**Sacramento
Cogeneration
Authority**

Procter & Gamble Cogeneration Project

**MINOR CHANGE IN USE OF INLET AIR CHILLER, REVISED SITE ARRANGEMENT,
AND CORRESPONDENCE TO THE CENTRAL VALLEY REGIONAL WATER QUALITY
CONTROL BOARD REGARDING HARDNESS AND TDS LEVELS FOR THE PROPOSED
PROCTER AND GAMBLE COGENERATION PROJECT (DOCKET NO. 93-AFC-2)**

**ENVIRONMENTAL IMPACTS OF
USE OF INLET AIR CHILLER FOR THE SIMPLE CYCLE UNIT**

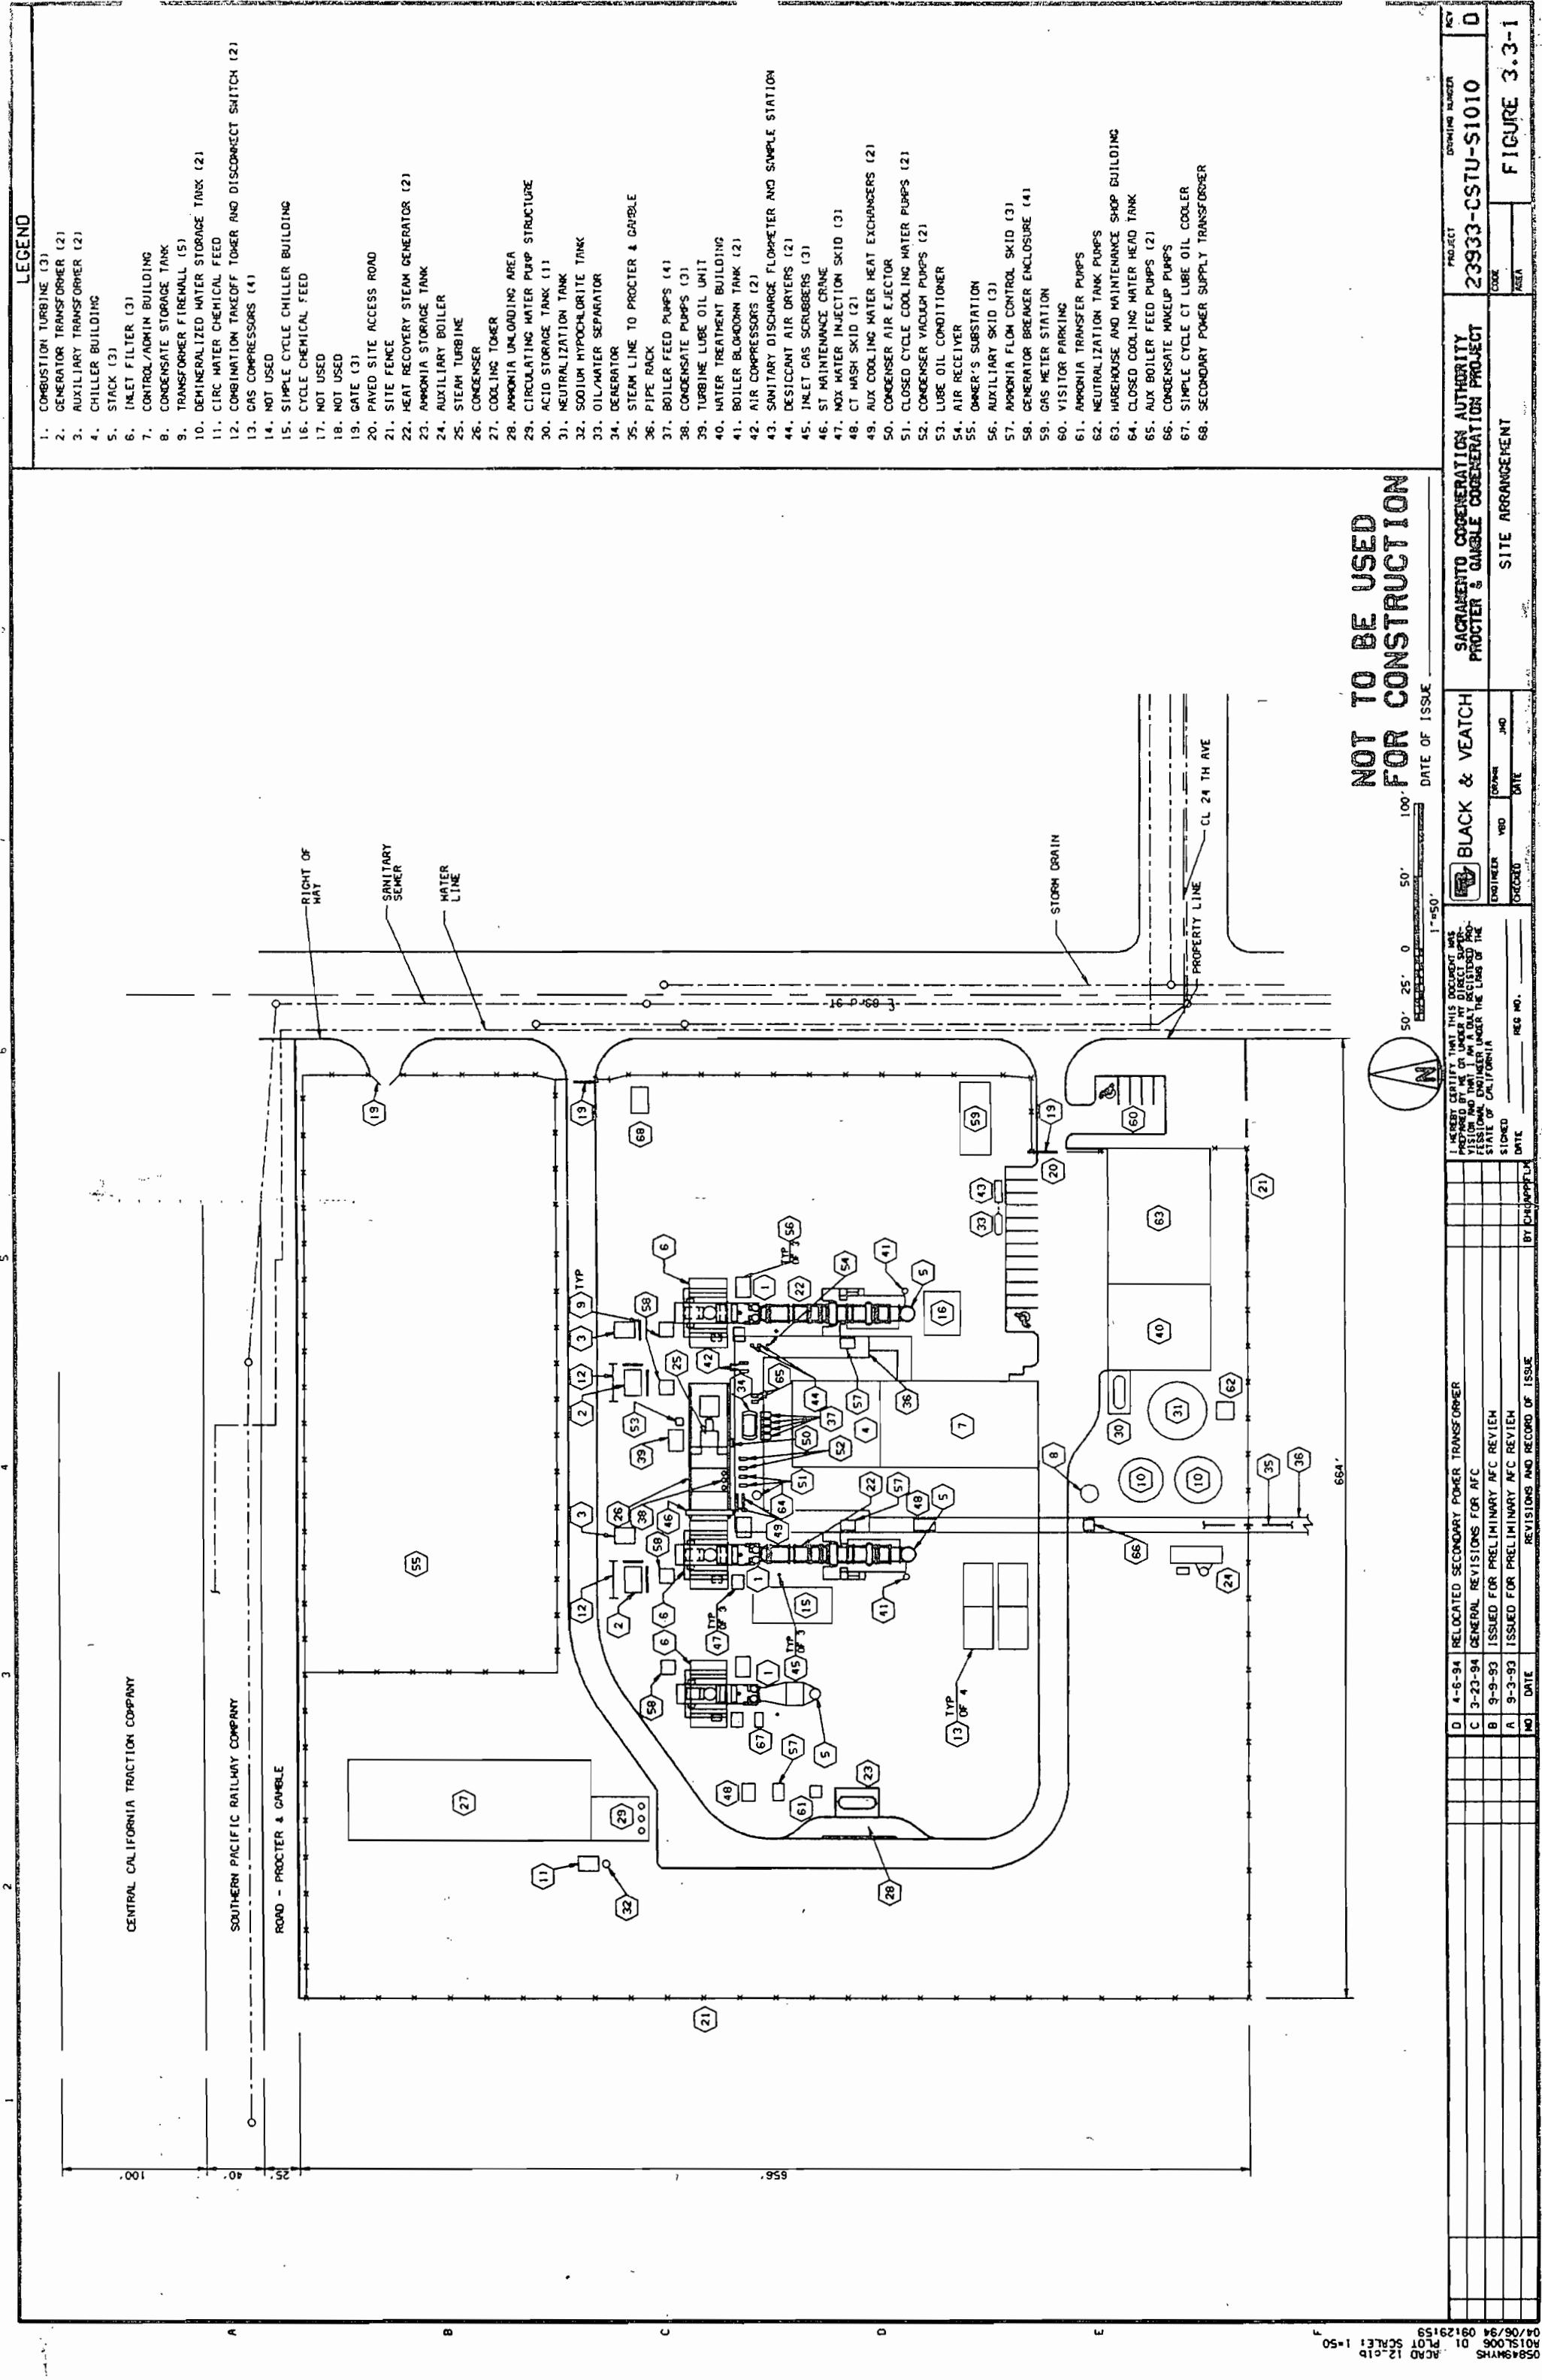
A revised project site arrangement (Figure 3.3-1) is also enclosed. The figure reflects the following changes submitted to the CEC to date:

- 1) the increased size of the cooling tower and simple cycle CTG chiller building,
- 2) the deletion of the standby generator and the addition of a secondary power feed transformer,
- 3) the revised ammonia storage area including a horizontal ammonia storage tank, and
- 4) the incorporation of handicap parking in the existing visitor and plant parking areas.

Please note that the secondary power feed will be from a 12KV distribution line in the area. The secondary feed, consisting of a 4160 volt feed to plant 4KV bus and approximately 2 MVA capacity will provide a black start capability for combined cycle and be used for construction power. Also enclosed is a copy of the March 17 correspondence sent to the CVRWQCB regarding project wastewater hardness and TDS levels.
